**ADDENDUM NO. 3
JUICE BUILDING PHASE 1
2% MBE PARTICIPATION**

**'JUICE' BUILDING
3975 DAYTON PARK DR.
DAYTON, OH 45414**

**PHASE 1 ALTERATIONS AND OCCUPANCY
ADDENDUM 03**

Phase 1 Improvements For:
Juice Building
Project #2A-17774
3975 Dayton Park Dr.
Dayton, OH 45414

E2.3

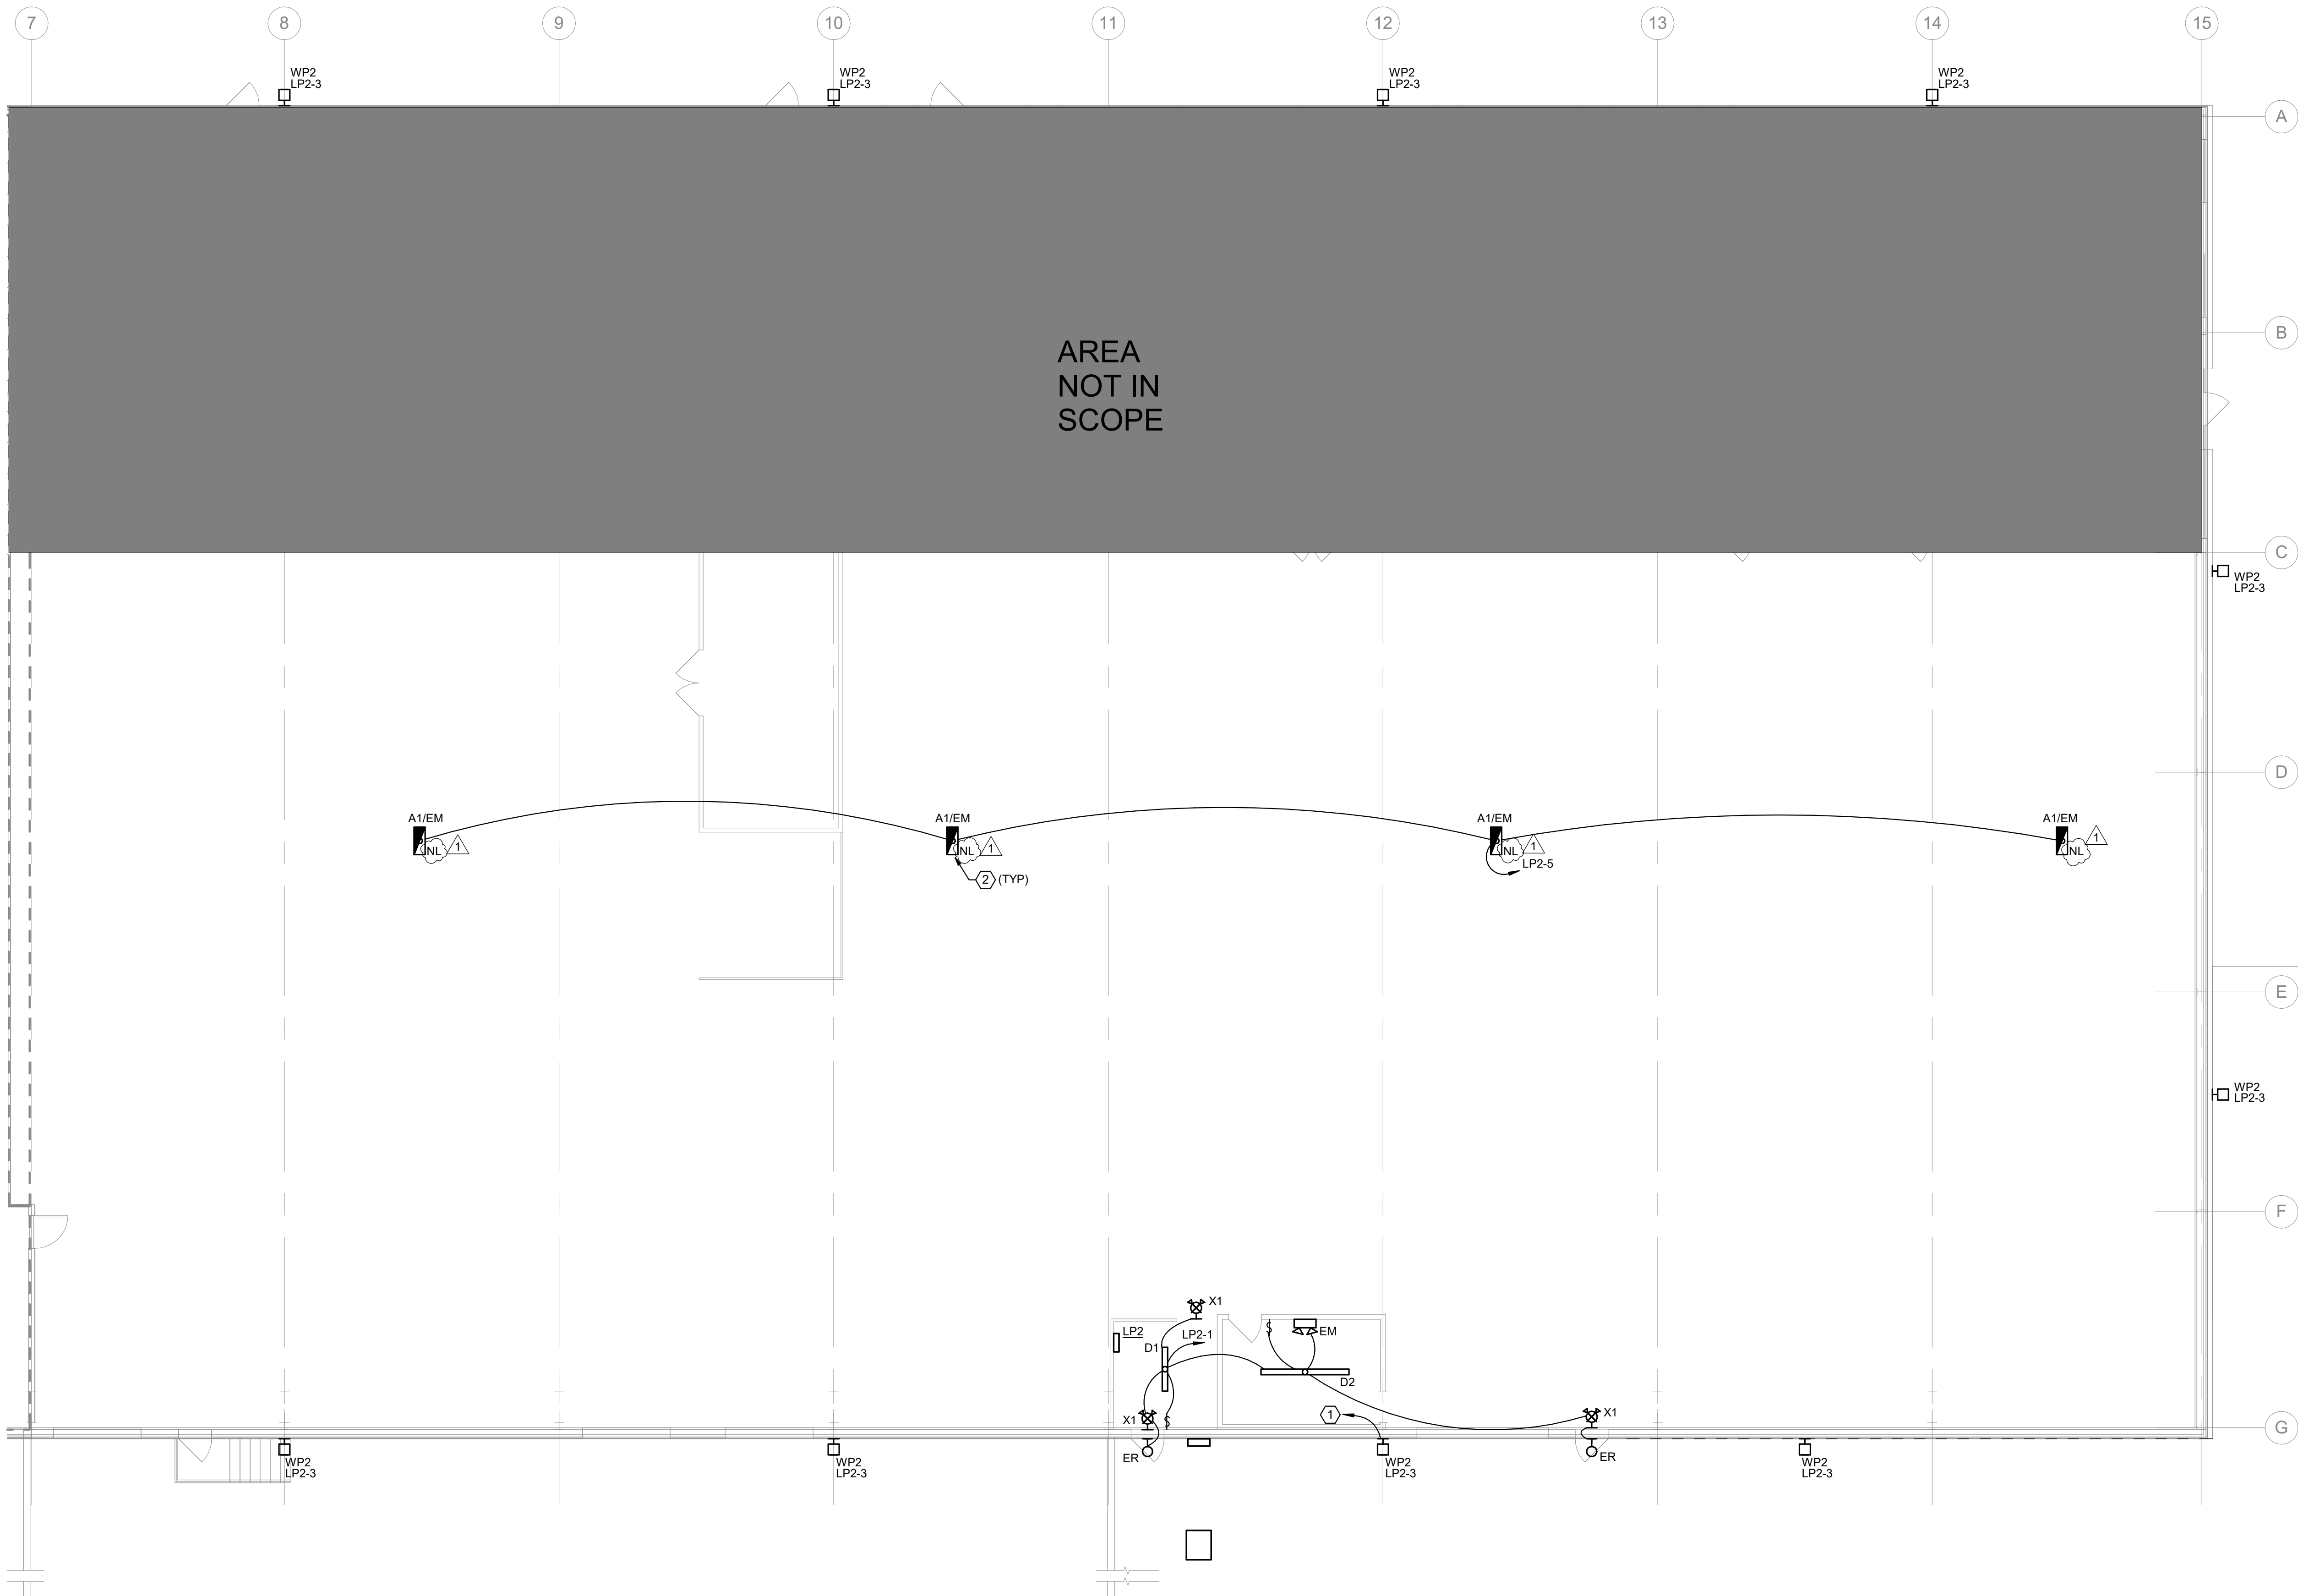
13. Sheet E2.3: REPLACE this sheet with the version attached to this addendum. Issued to clarify NL locations. A1/EM fixtures are considered night lights.

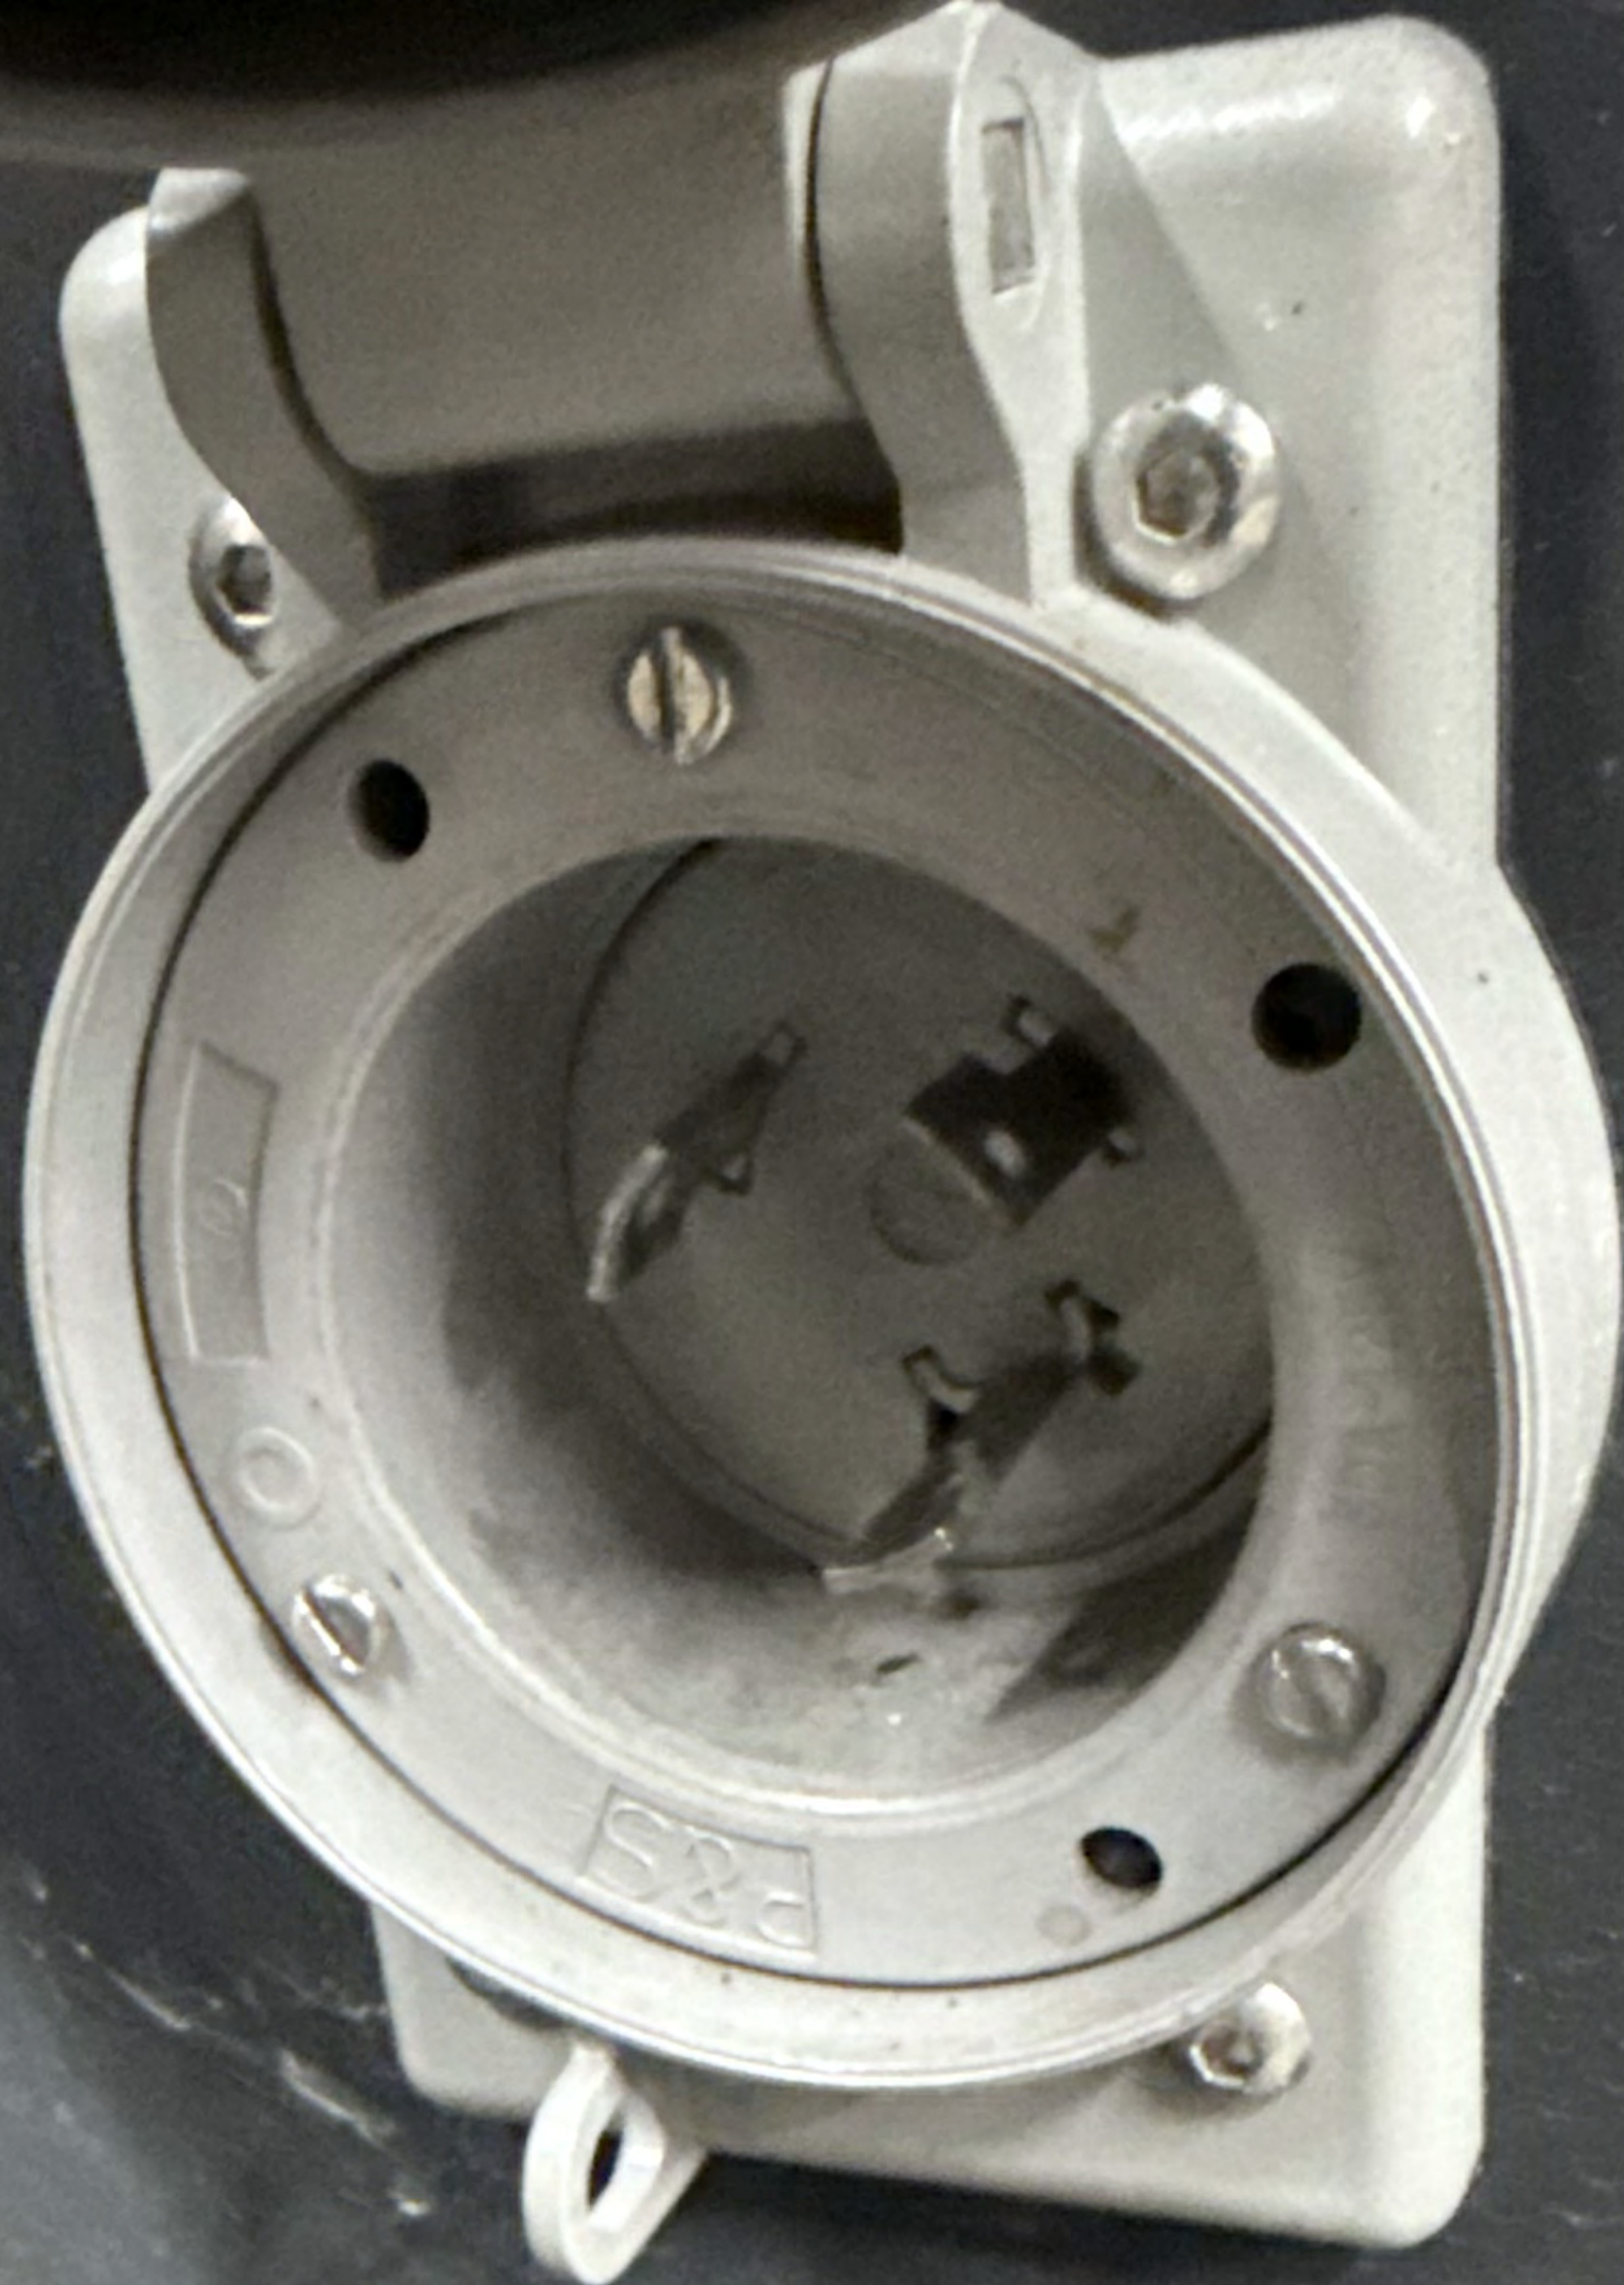
14. Sheet E4.1: REPLACE this sheet with the version attached to this addendum. Revised single line diagram.
15. Sheet E4.1: CLARIFICATION: Equipment noted as 'Future' is not included in Phase 1 work. Future equipment has not been designed or specified.
